# **PUBLIC IMPROVEMENT REQUEST FOR PROPOSAL**

**RFP# 23-22**

## **PONTIAC, SWIFT, MOORE AND WRIGHT WATERMAIN AND RESURFACING PROJECT**

City of Ann Arbor  
Public Services / Engineering Unit

c:\pw\_work\mflanagan\dl1253461\CPS-PLTS-Signage.dwg Dwg Created: 6-Apr-23 -- \_a2 standard bw.stb -- Plot Date: 13-Apr-23

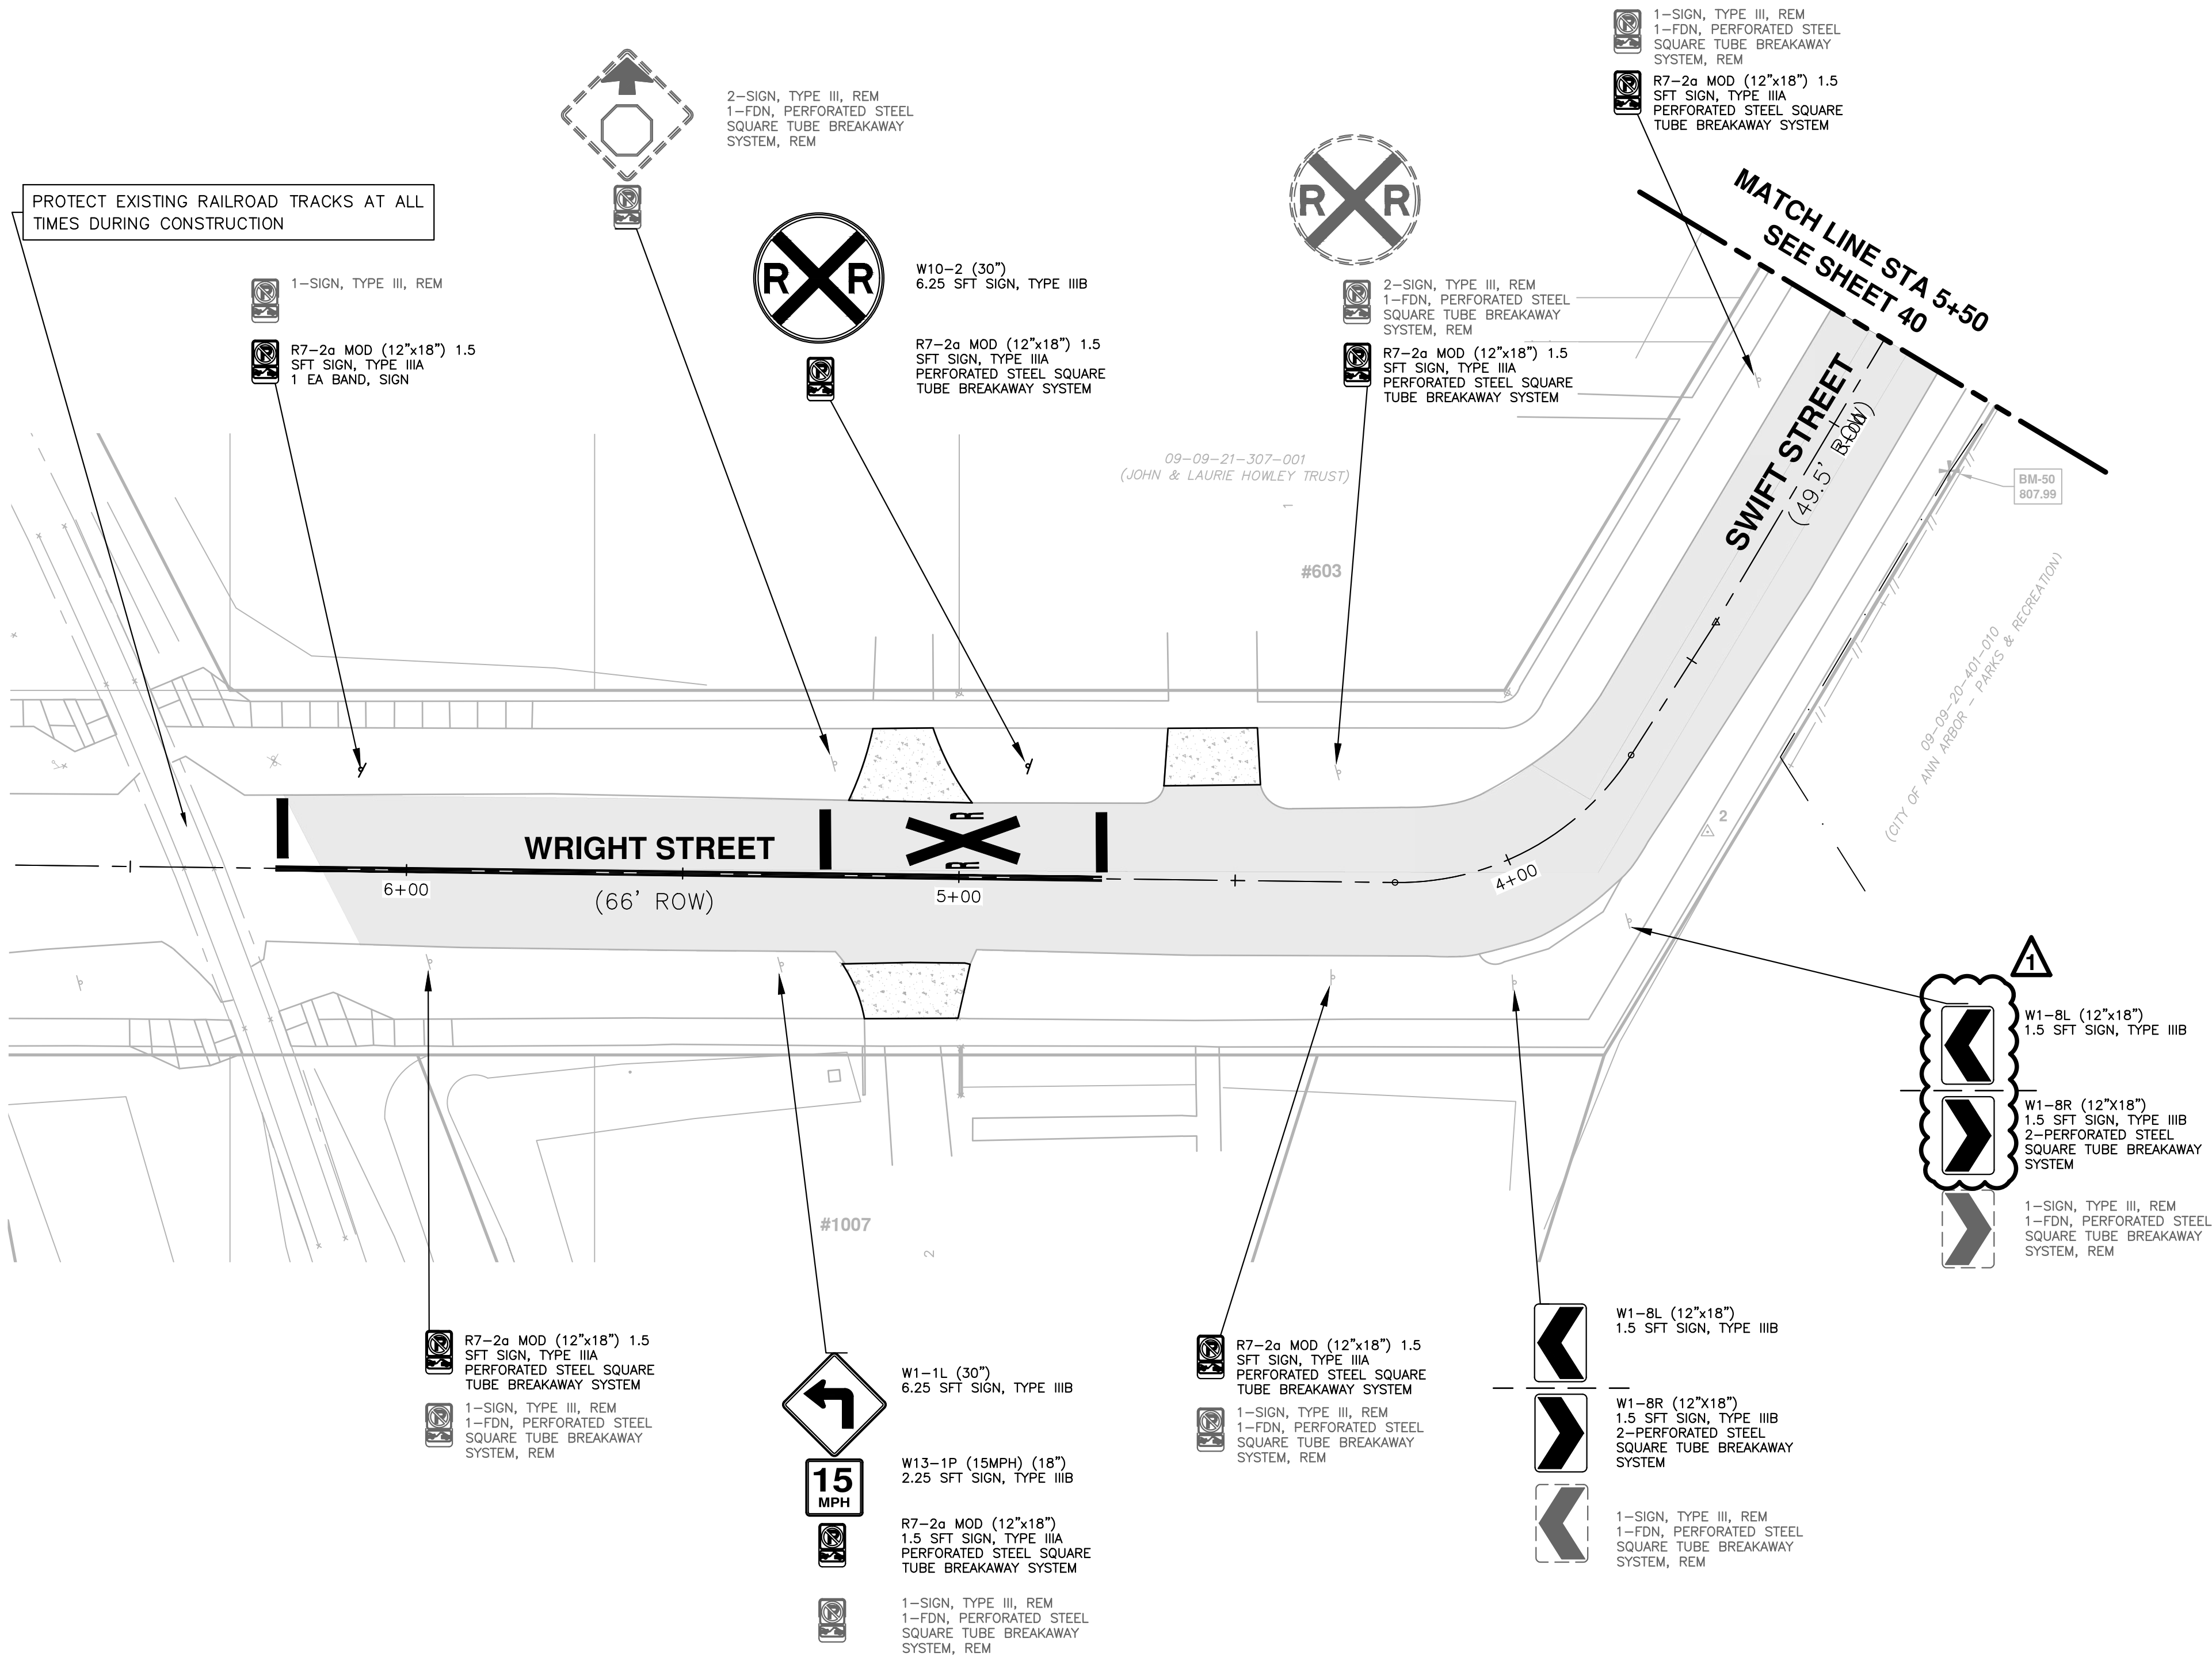
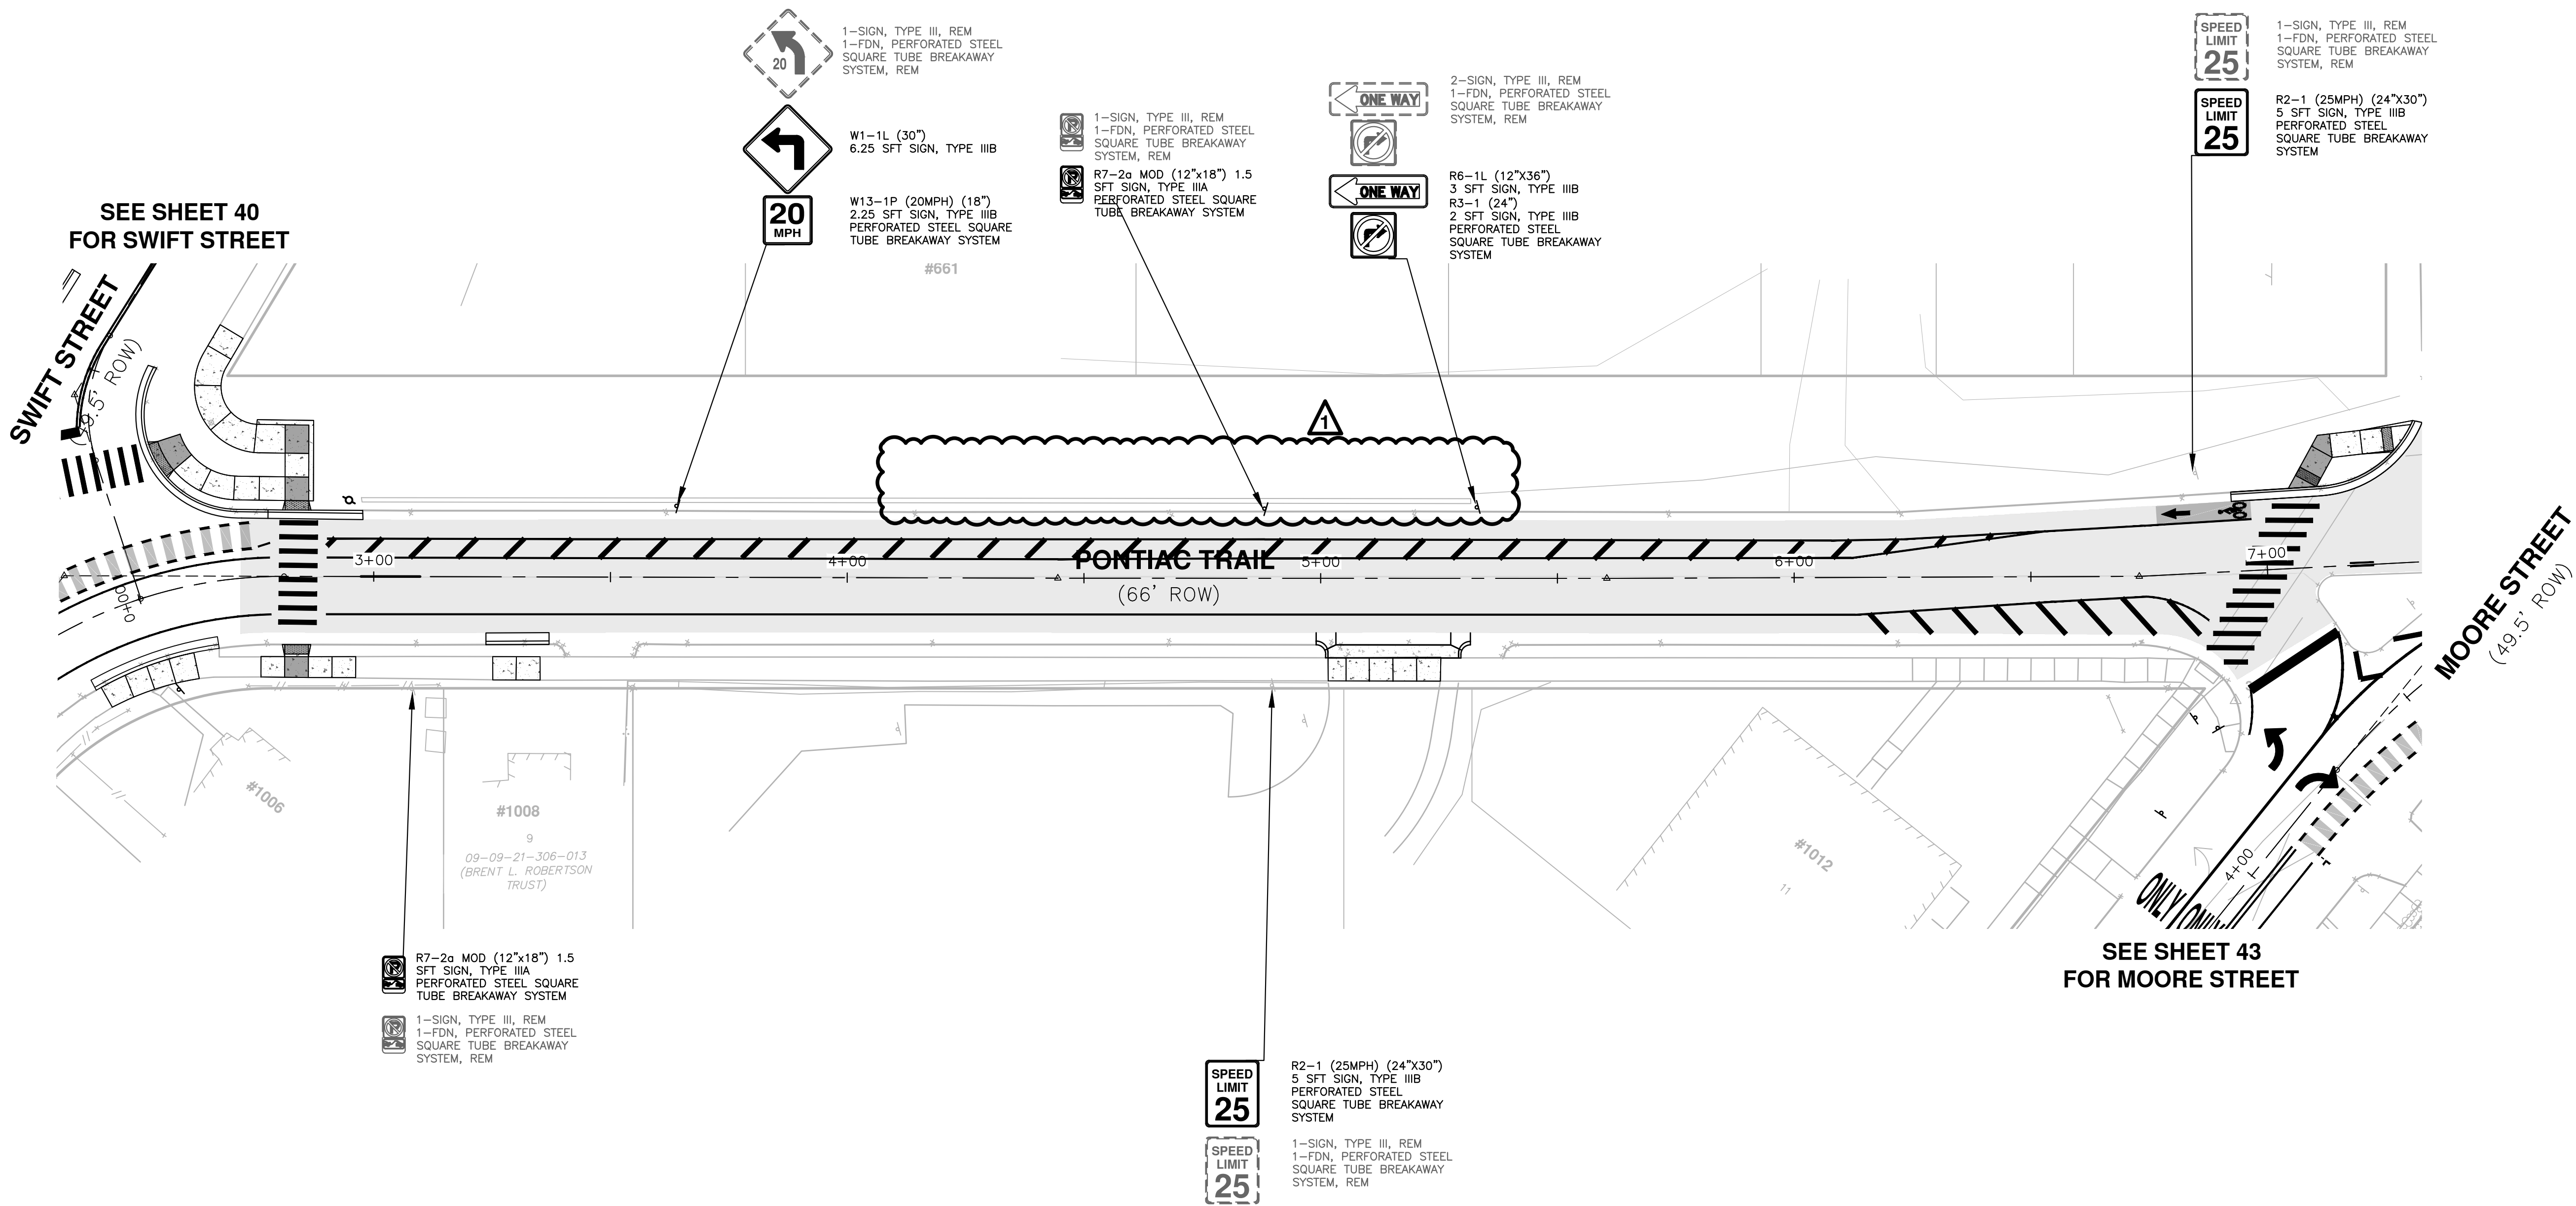
Section/Page(s)	Change
Page DS-232 to DS-235	Temporary Water Main, Wright Street: Updated to state water service connection preference, increase depth of cover requirement an other minor items.
Plan Sheets 38-42	Pavement marking plan updates include: <ul style="list-style-type: none"><li>• Minor revisions to pay item language (transv vs. longit)</li><li>• Correction to naming convention (recessing vs. recess)</li><li>• Removal of railroad crossing symbol on Moore Street</li><li>• Minor signing changes</li></ul>
Page E1-E4	The bid form has been amended to reflect the modifications of this Addendum No. 1 and other quantity corrections from original contract documents.
